**SAFETY RECALL**

**2021 CBR1000RR-R (SP) - REAR CUSHION CONNECTING PLATES**

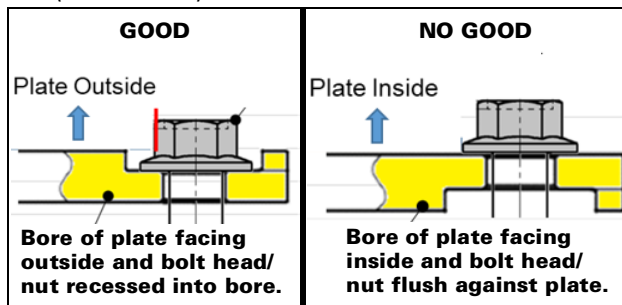
1. Visually check that the bores of the left and right rear cushion connecting plates are facing outside.

The cushion connecting plate bolt head and nut should both be recessed into the bores of their plates if installed correctly (as shown).

- If the motorcycle has the plates installed correctly, no repair is needed. Immediately file warranty template claim KL9A for INSPECTION ONLY.
- If the motorcycle does not have a plate installed correctly, a repair is needed. Contact TechLine for repair determination and parts information. **DO NOT** file a warranty claim at this time.
